Docket Item # 1
BAR CASE # 2011-0135

BAR Meeting
June 22, 2011

ISSUE: Door and window replacement

LOCATION: 1108 Queen Street

Figure 5. Existing and proposed front (north) and rear (south) elevations.

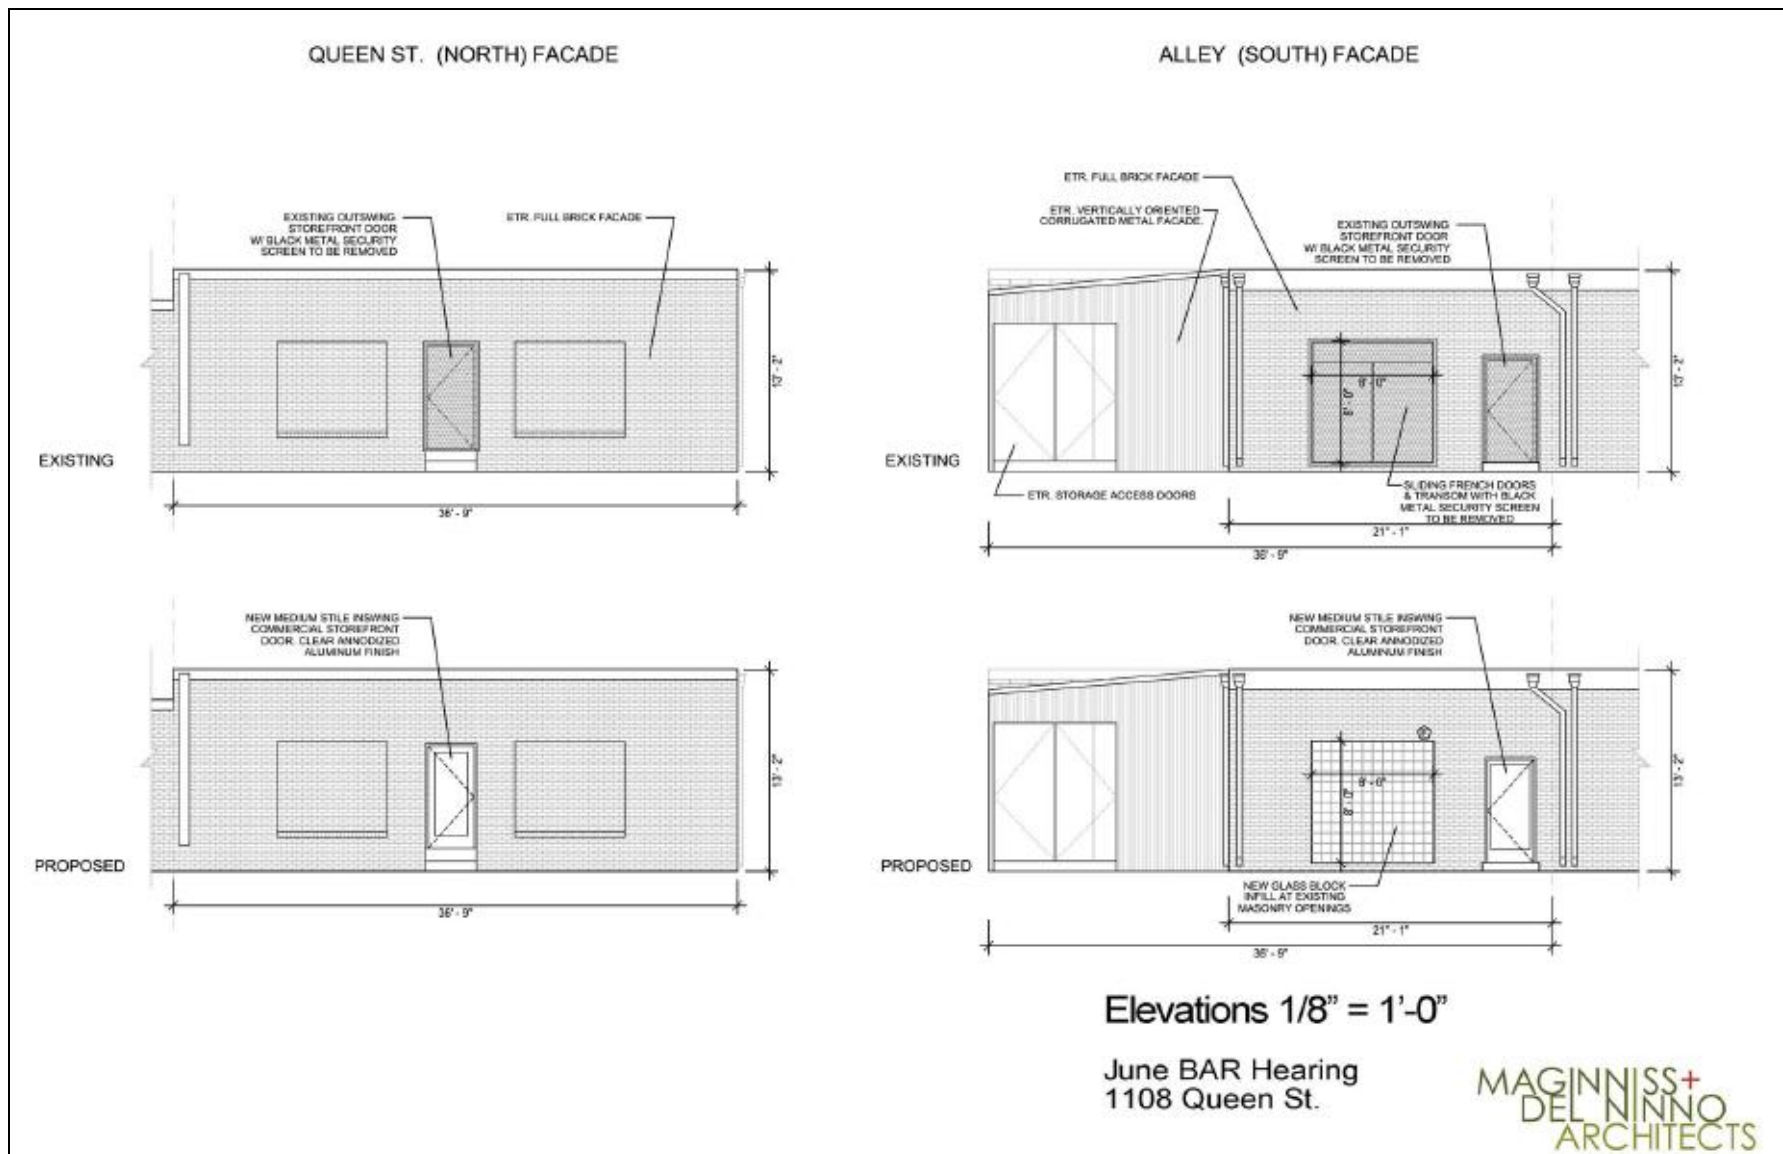
Staff has no objections to the use of single-light glass and aluminum doors on the front and rear elevations, finding them appropriate to the commercial architecture of the building.

Staff encouraged the applicant to consider opening up the existing bricked-in windows on the front elevation. Bricking in these windows was likely done prior to the creation of the Parker-Gray Historic District in 1984, as Staff would not now support such an alteration to a storefront façade. Although at this time the applicant wishes to leave these openings blocked, Staff notes

C-3 Note that if the outward swing of the entrance/exit doors is the result of occupancy they must continue to swing in the direction of egress

Figure 6. Proposed side (west) elevation.

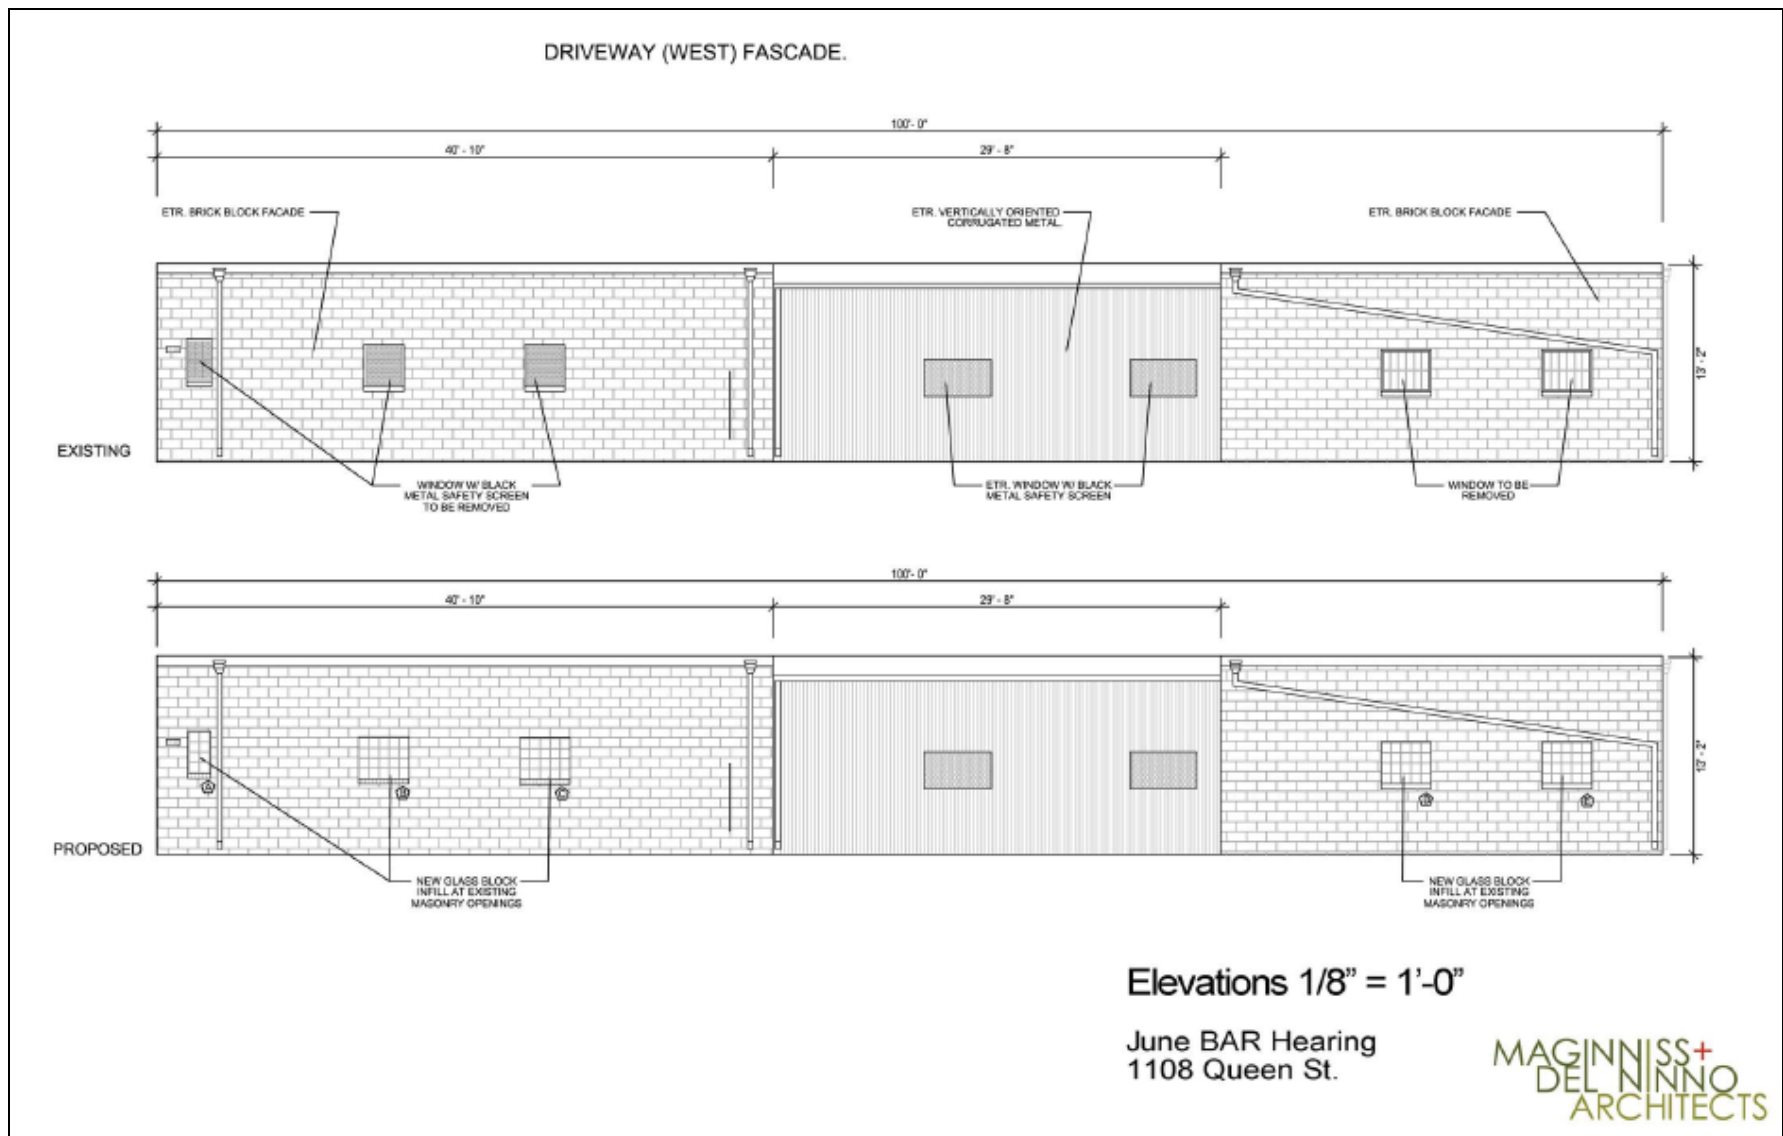
Staff is generally supportive of the proposed alterations for this mid-century commercial building. The *Design Guidelines* note that “new and replacement windows should be appropriate to the historic period of the architectural style of the building.” In addition, the *Guidelines* note that “glass block may be appropriate on both commercial and residential buildings dating from ca. 1920 to 1950.” Staff has no objection to the use of glass block for the five windows on the side elevation, all of which currently have black metal security bars. Staff is less enthusiastic about the use of glass block to replace the existing French doors since this alteration essentially converts doors to fixed oversized windows. However, these doors are on the rear elevation amid a parking area and garage entrances (the existing French doors were likely a garage entrance at one time). The rear overlooks a parking and alley area used by a mechanic business. Furthermore, Staff notes that the conversion to glass block is a reversible change and a future owner or tenant could return the glass block to a garage door or French doors.
